Access Compliance Report Public Rights-of-Way (Curb Ramps)

Main Street: LARKRIDGE_DR Cross Street: GLENKNOLL_DR Location: NW

ADA ID: RPAT210923092400 Ramp Type: Type 1 - Perpendicular Diagonal Initial Pass/Fail: Fail Overall Compliance: No Severity Score: 2

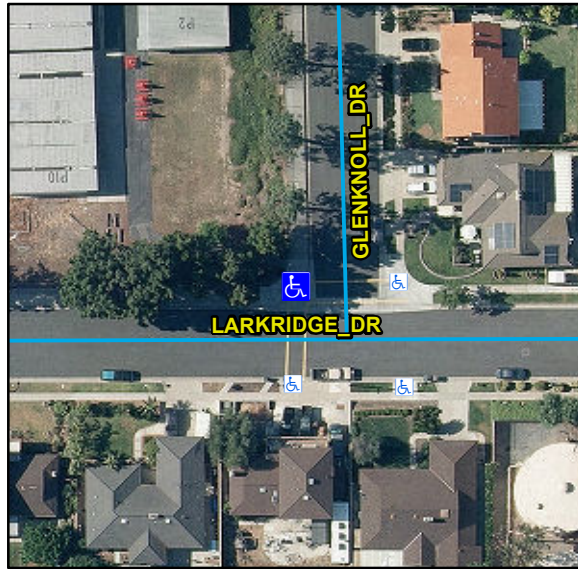
R304.2.2, R304.5.3, STD 1115

Remove & Replace Curb Ramp With Two New Directional Ramps or Equivalent.
